Heavy Vehicle Local Road Report for Use of Local Roads

Hunter Street East Construction Site - Rev B

Project number	7040
Document number	SMWSTETP-JCG-SCB-SN100-TF-RPT-093006

Hunter Street East – Proposed Haulage Routes

PROJECT	SYDNEY METRO WEST - EASTERN TUNNELING PACKAGE				
TITLE	SWEPT PATH ANALYSIS - GRESHAM STREET AND BENT STREET AS2890.2 12.5m HEAVY RIGID VEHICLE

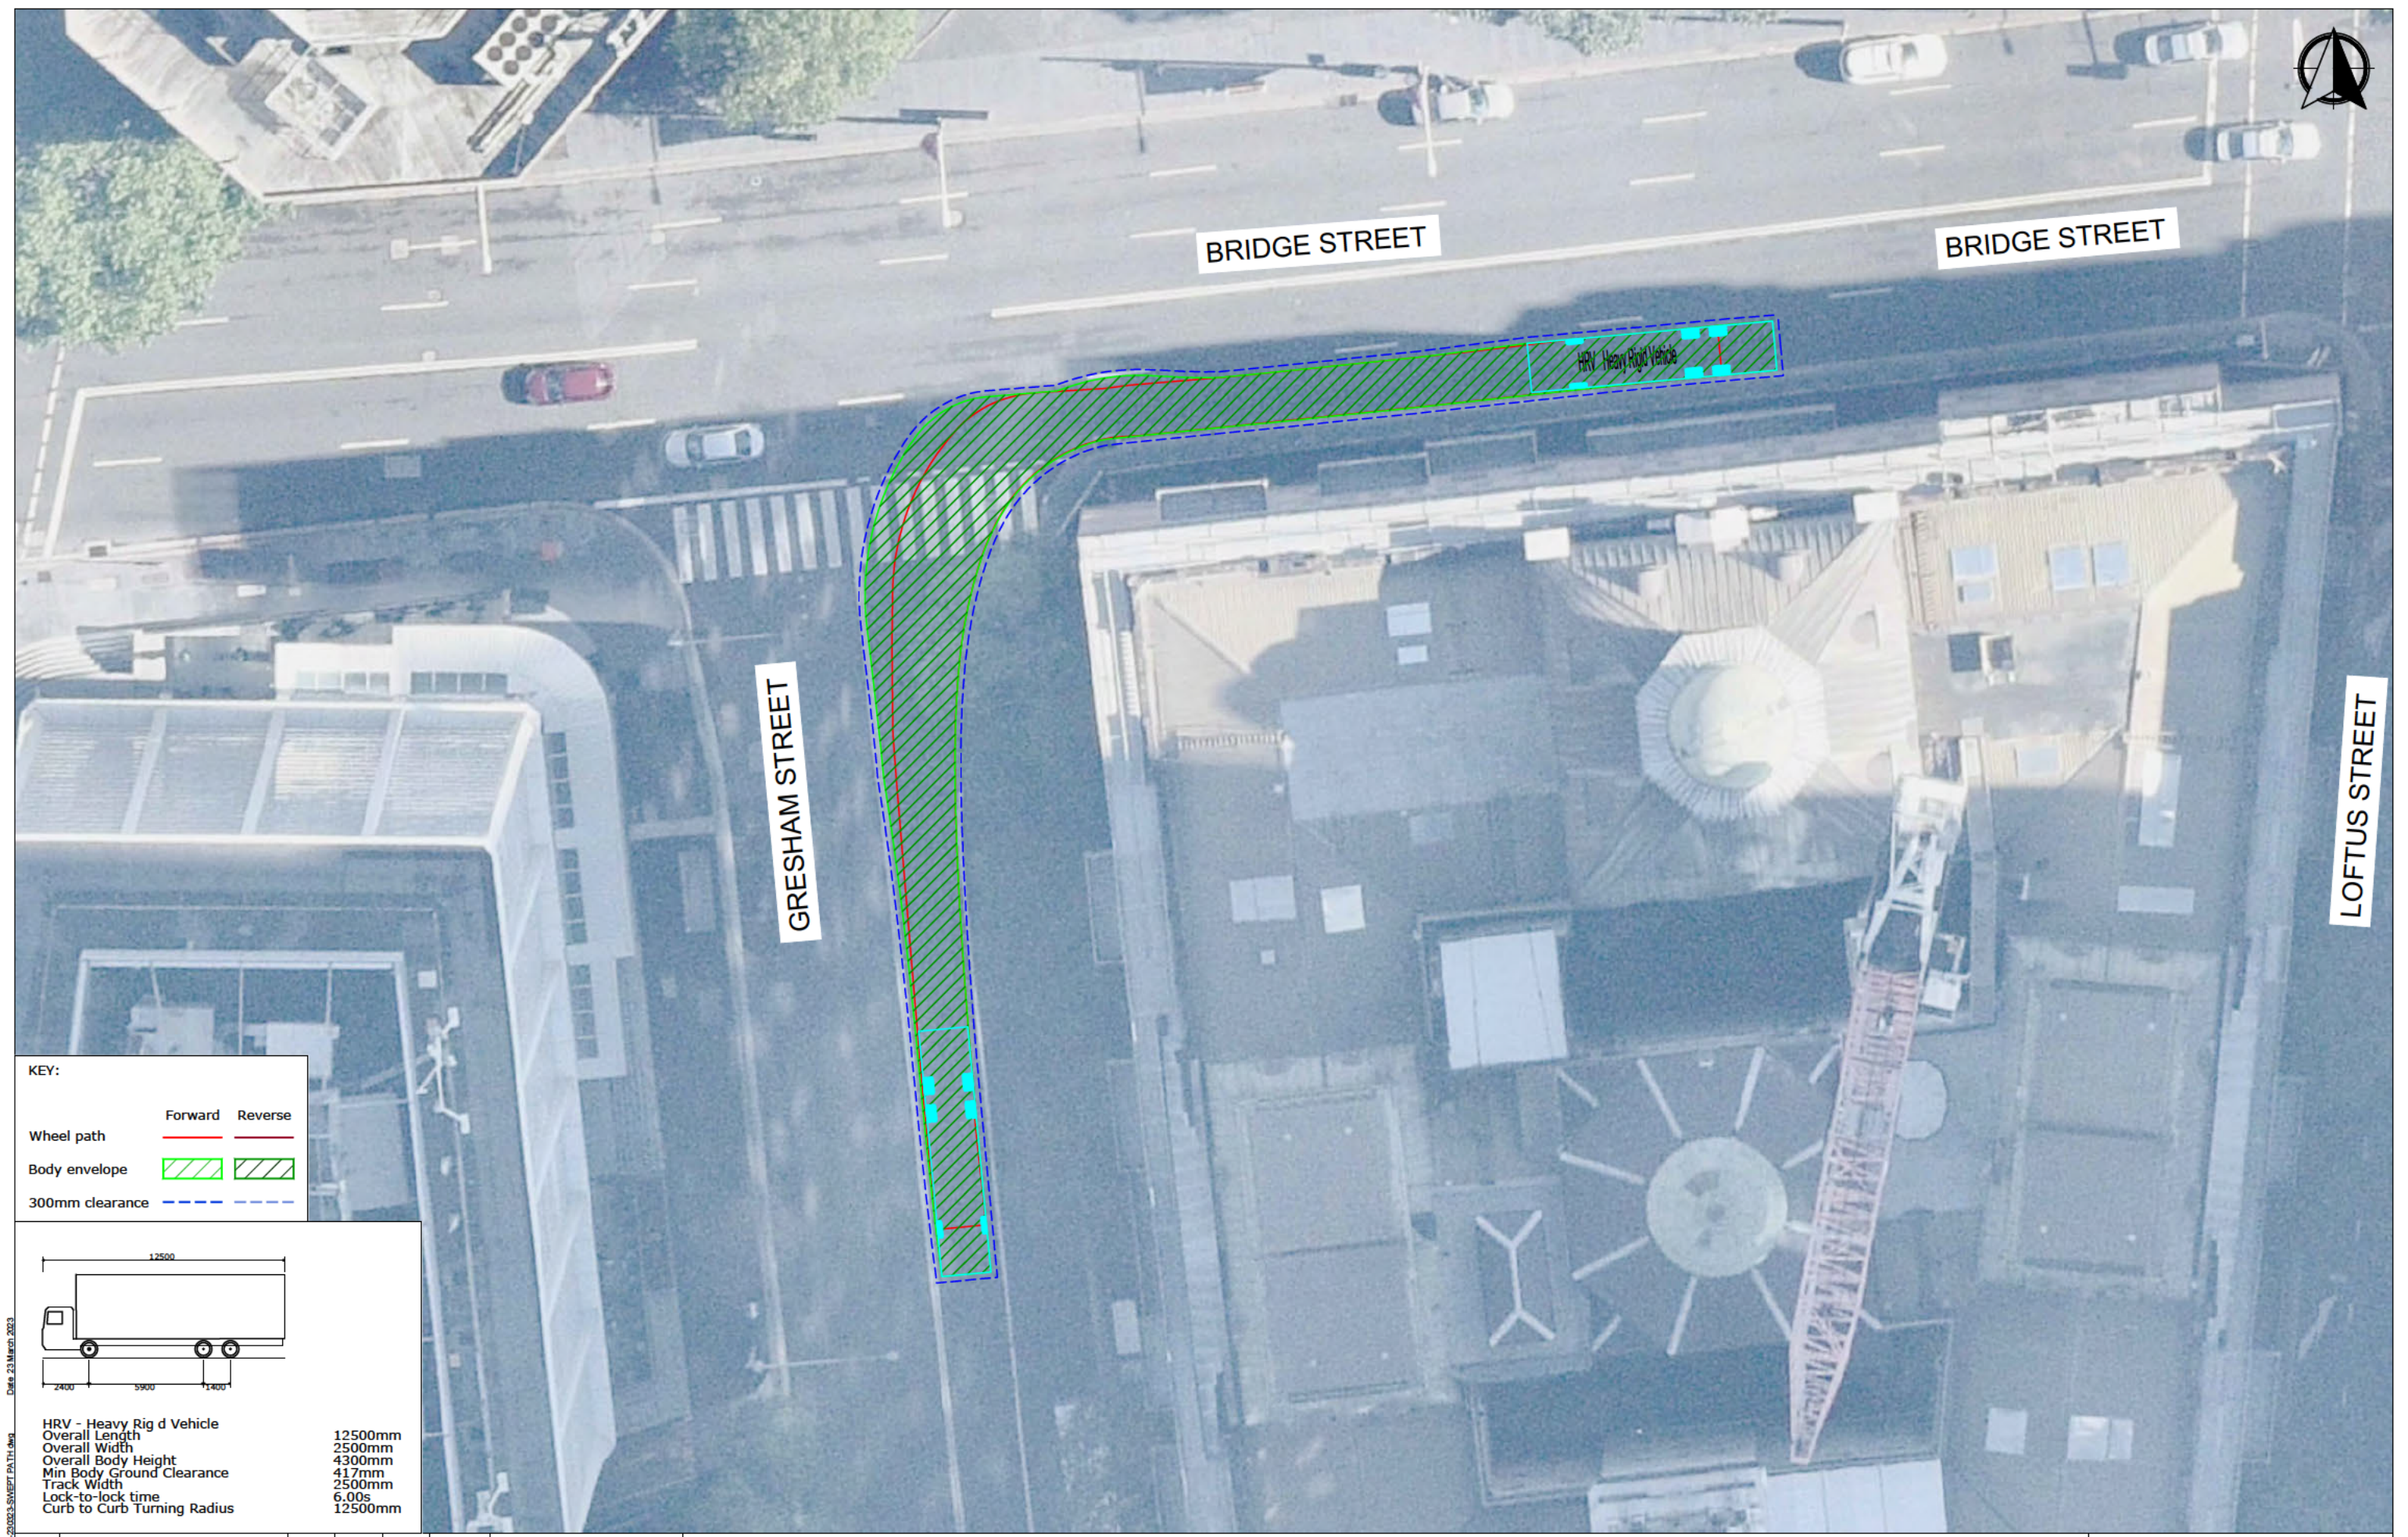
Item No.	Location	Descriptions of Findings	Photo	Likelihood	Severity	Risk Rating	Designer Response
2.	Gresham Street – Bent Street	The swept path appears to show HRVs turning left from Gresham Street into Bent Street would cross over the centre line and travel in the opposing lane to complete the turning manoeuvre. This could potentially result in head-on, side swipe crashes and minor injuries.	 	Possible	Insignificant	Low	The swept path diagram for the Gresham Street to Bent Street left turn movement has been refined for not encroaching the centreline and the kerbside lane. Refer to Attachment Three.

DWG No.	21480CAD-HU FIGURE 13		
DATE STAMP	23 MARCH 2023		
PROJECT No.	SCALE	REV.	
21480	1:200 @A3	A

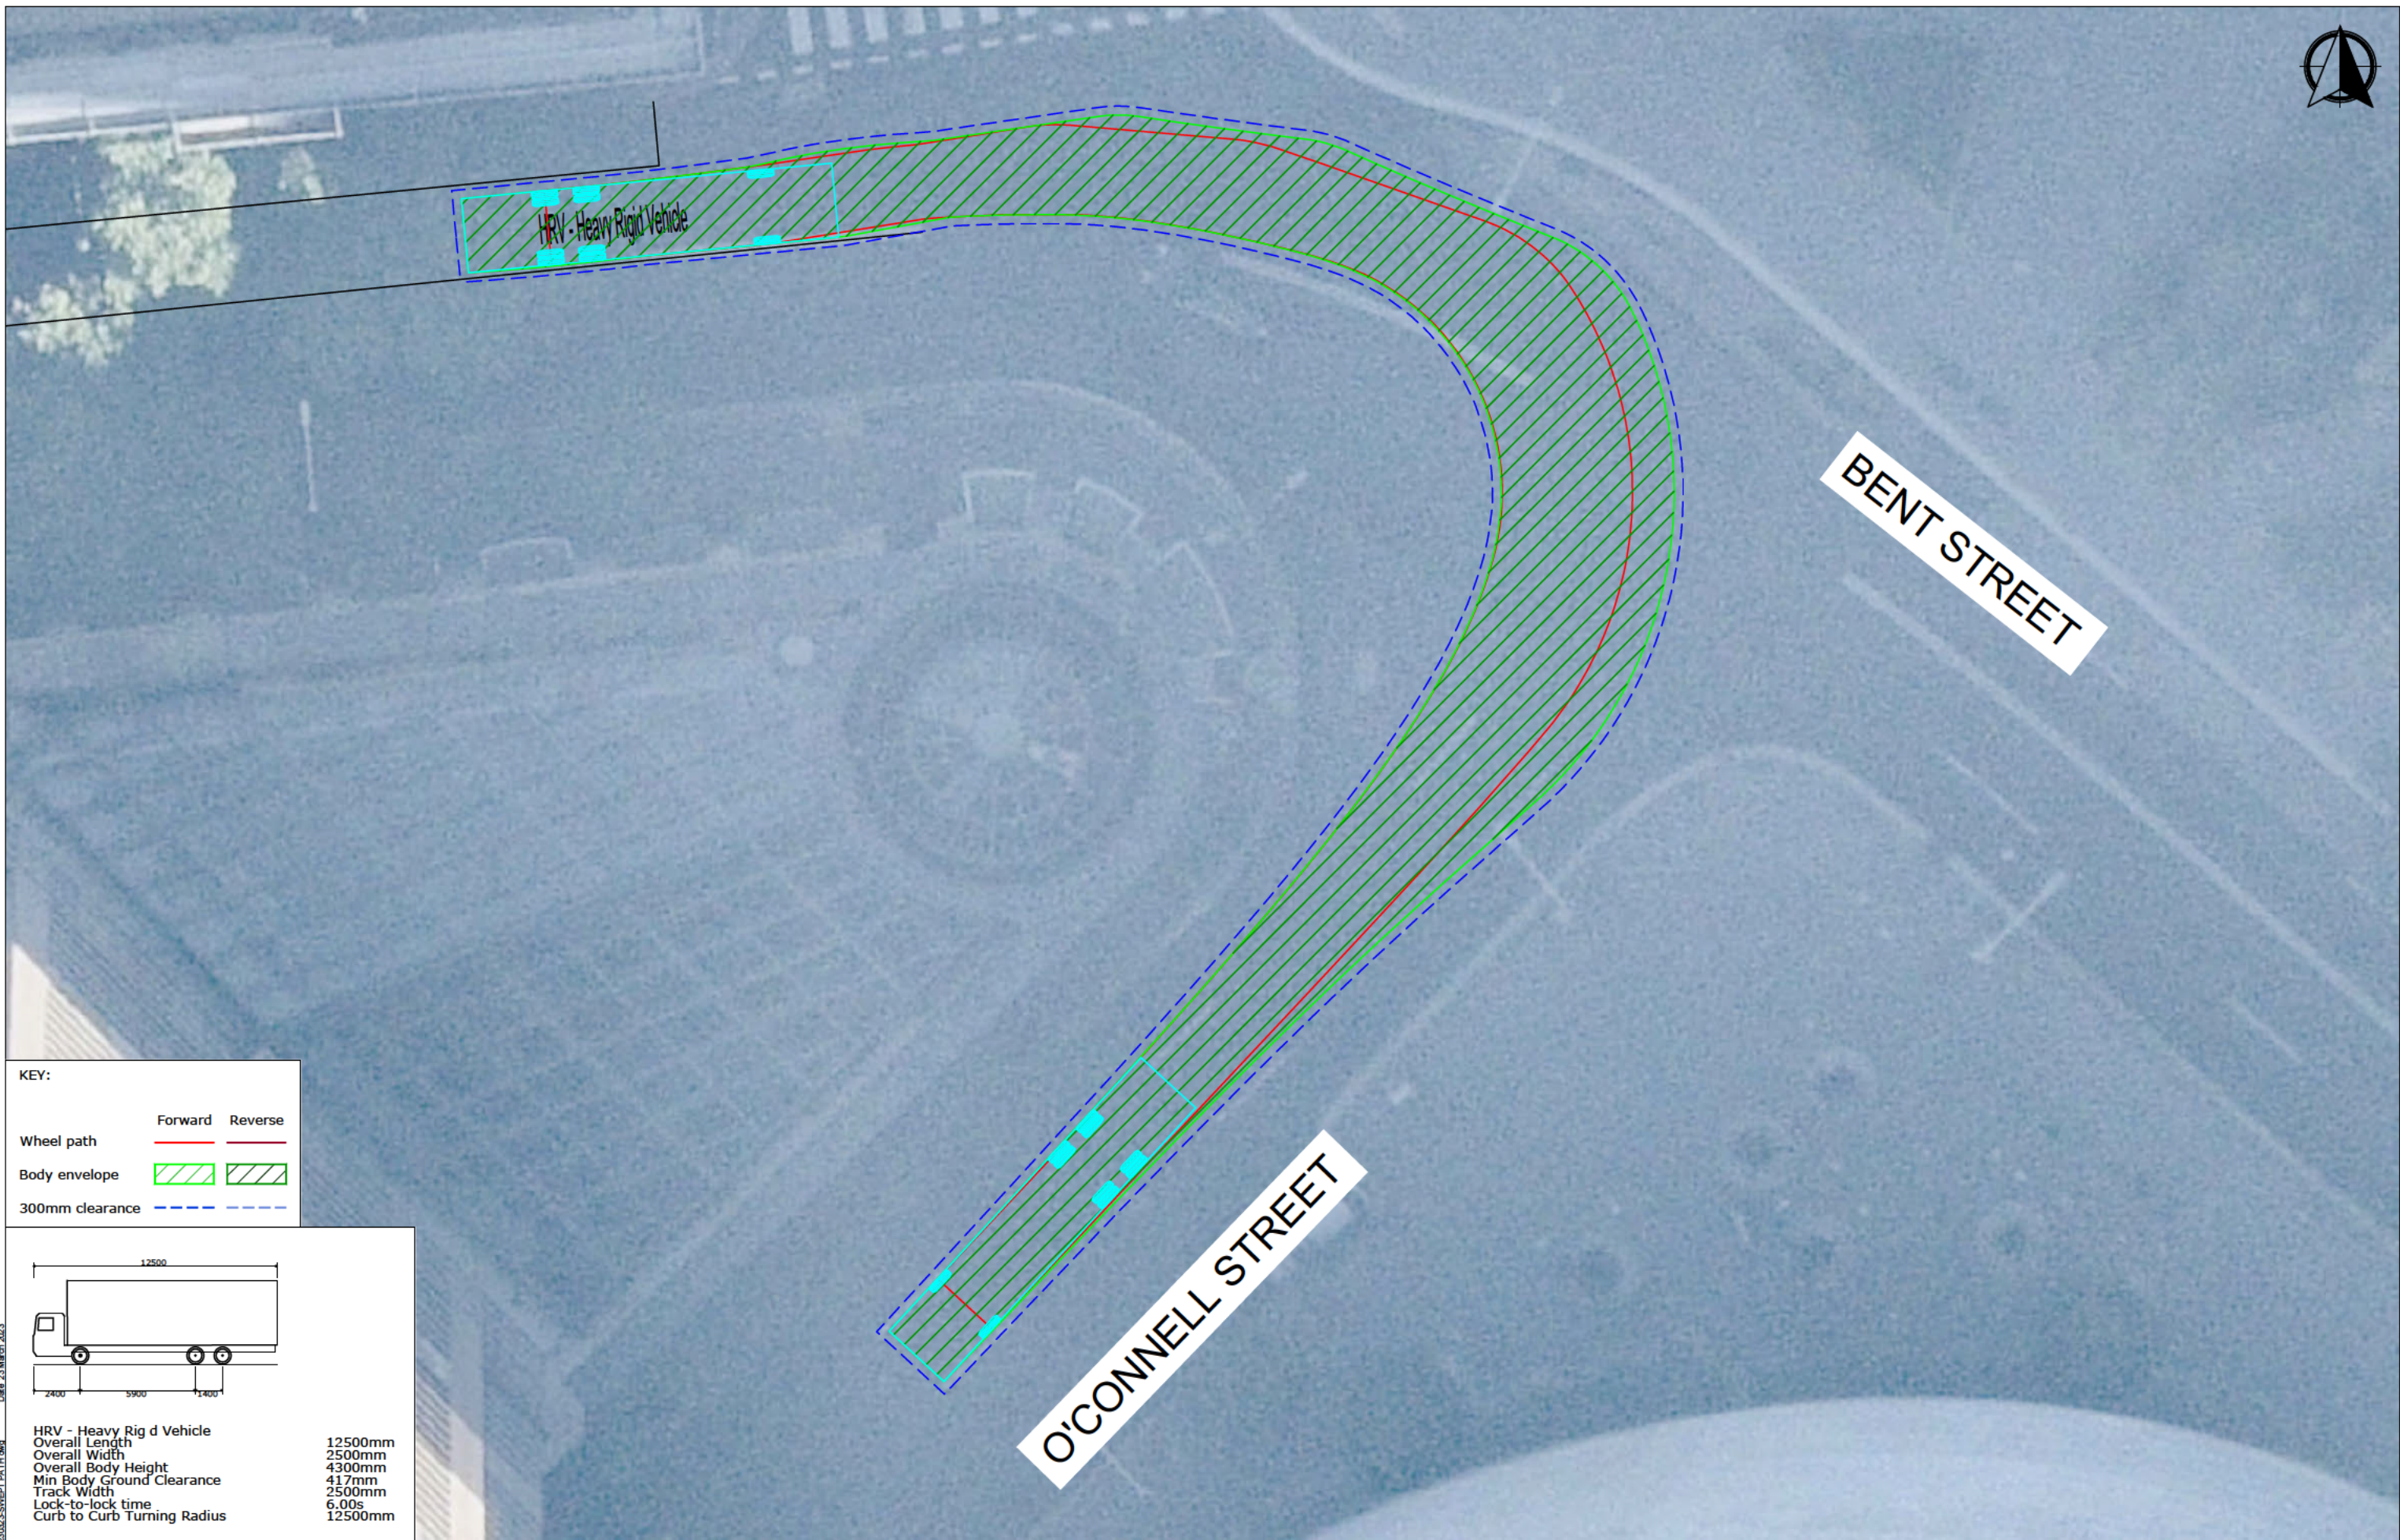
Item No.	Location	Descriptions of Findings	Photo	Likelihood	Severity	Risk Rating	Designer Response
1.	Bent Street – O'Connell Street	Bent Street has a designated taxi rank opposite the intersection with O'Connell Street and occasionally have taxis queuing out of the waiting zone. Taxi that spills out of the zone was observed to be parked at an angle, limiting the manoeuvring space for a HRV to turn right from Bent Street into O'Connell Street. This may lead to an HRV waiting to turn right crosses over the centre line while waiting to turn in the path of an oncoming vehicles, potentially resulting in head-on, side swipe crashes and minor injuries.		Possible	Insignificant	Low	<p>The part time taxi zone is approximately 19m long, which is sufficient to accommodate three taxis but another taxi may squeeze in with the rear of the taxi sticking out in the No Stopping zone, as shown in the photo.</p> <p>While this may occur at times, it is outside the control of JCG JV, however the swept path diagram for the Bent Street to O'Connell Street right turn movement has been refined to enable sufficient buffer in case a taxi spills out of the taxi zone.</p> <p>Refer to Attachment Three.</p>
